Title - Sujet CCGS George R. Pearkes - VLE	
Solicitation No. - N° de l'invitation F7049-200083/A	Amendment No. - N° modif. 008
Client Reference No. - N° de référence du client F7049-200083	Date 2022-05-02
GETS Reference No. - N° de référence de SEAG PW-\$\$\$MD-029-28531	
File No. - N° de dossier 029md.F7049-200083	CCC No./N° CCC - FMS No./N° VME
Solicitation Closes - L'invitation prend fin at - à 02:00 PM Eastern Daylight Saving Time EDT on - le 2022-06-07 Heure Avancée de l'Est HAE	
F.O.B. - F.A.B. Plant-Usine: <input type="checkbox"/> Destination: <input type="checkbox"/> Other-Autre: <input type="checkbox"/>	
Address Enquiries to: - Adresser toutes questions à: Jeddi, Loubna	Buyer Id - Id de l'acheteur 029md
Telephone No. - N° de téléphone (873) 45--383 ()	FAX No. - N° de FAX (819) -
Destination - of Goods, Services, and Construction: Destination - des biens, services et construction:

Solicitation Amendment # 008

- 1. To include Questions and the Responses for the solicitation.**
-

Standard ceiling panel system

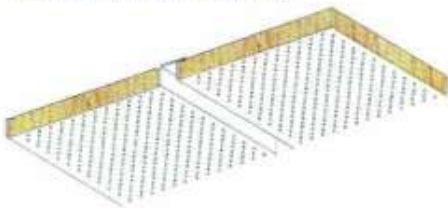
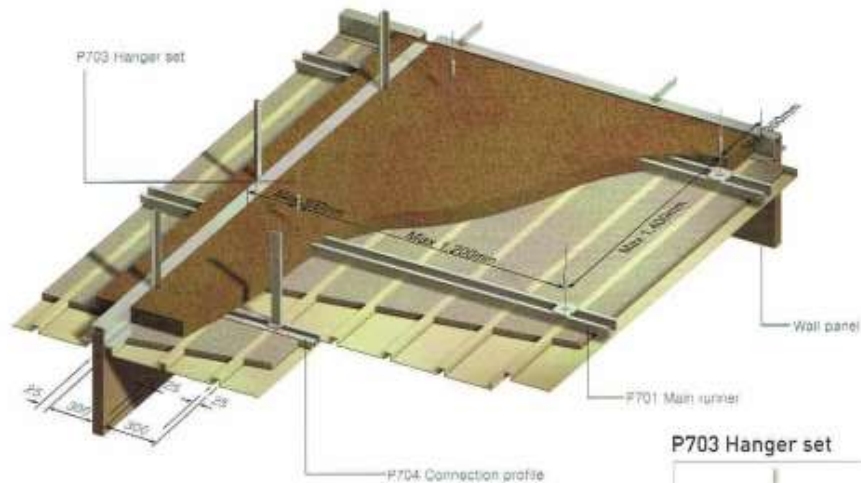
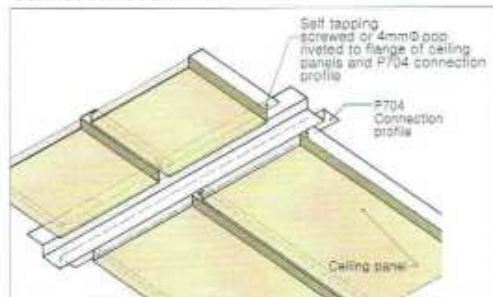
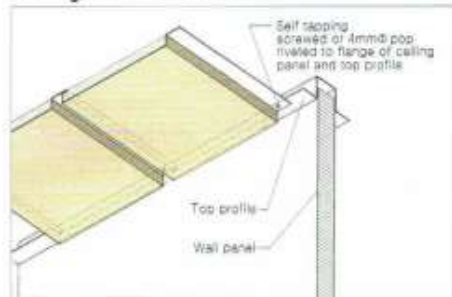
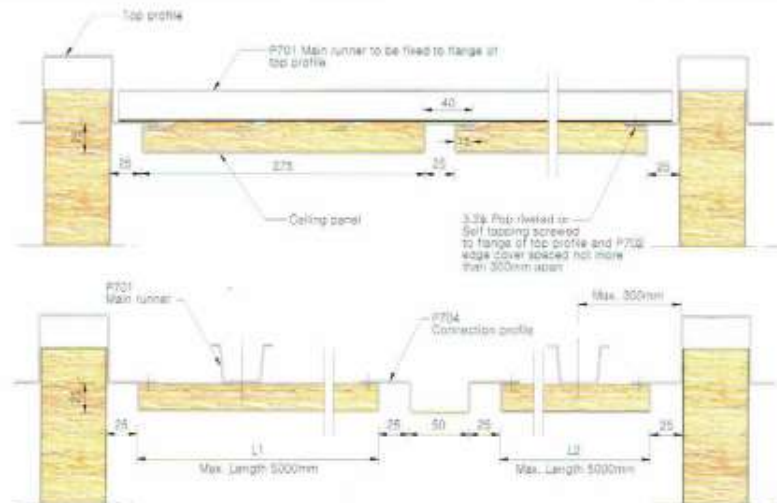
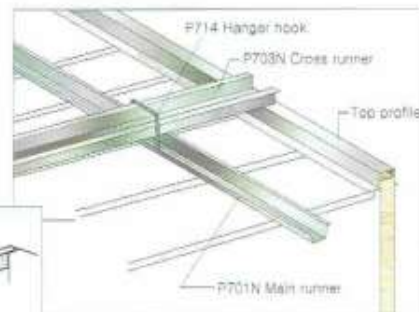
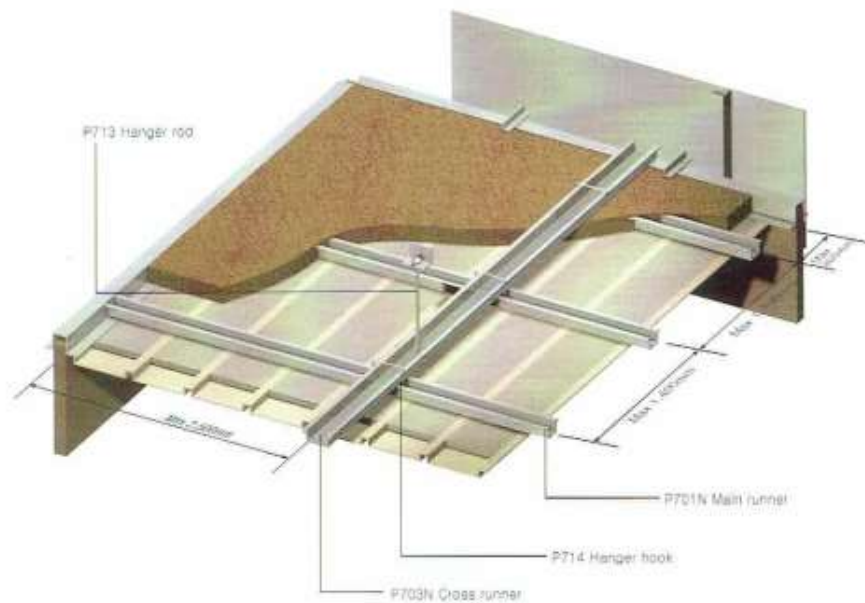
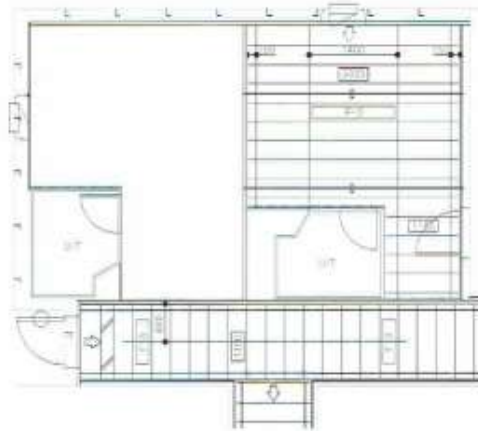
3.3.3 the contractor must supply and install new solid deck head panels. New panels must be the same as the existing to insure fitment into existing mounting tracks.
Is there pictures/measurements of existing?

The washroom ceiling panels are solid, non-perforated and are 300mm in total width. Technical specification sheets for ceiling panels are attached at the end of this AMD.
